SERVICE BULLETIN

Subject: TS45 TIRE BALANCING

Bulletin No: TS45-FC-2508

Vehicle Model : TS45

TECHNICAL INSTRUCTIONS

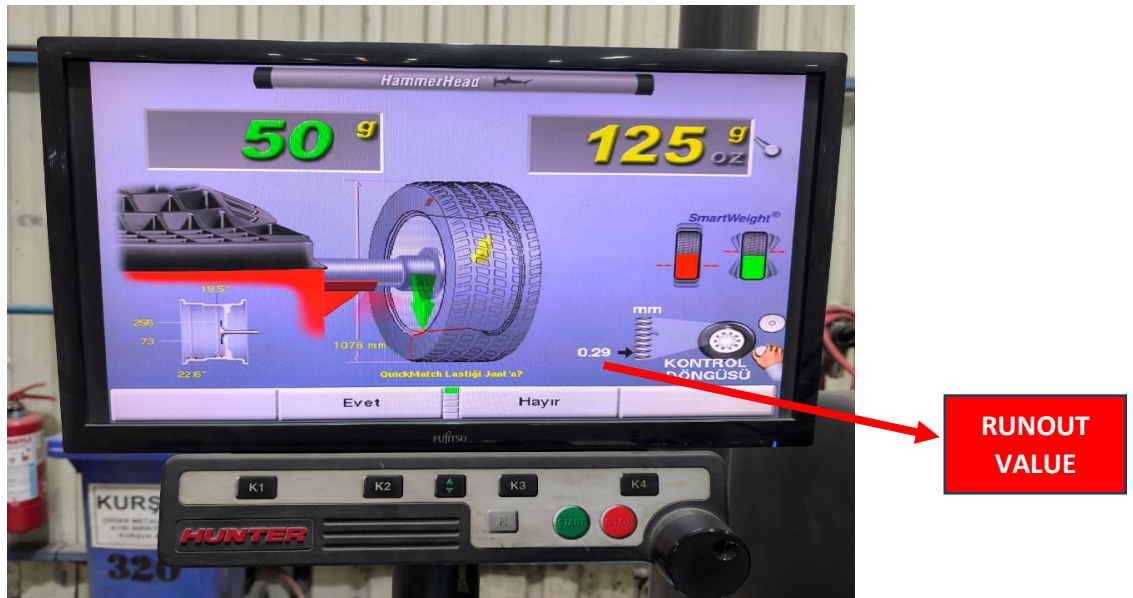
1. Vehicles that feel vibration should be balanced.
2. Tires should be removed and balance (runout values) measurements should be made one by one.
3. Runout values above '1' should be balanced and reduced to below '1'.

4. If the runout value cannot be reduced below '1', the tire should not be used. It should be replaced with another tire with a runout value below '1'.
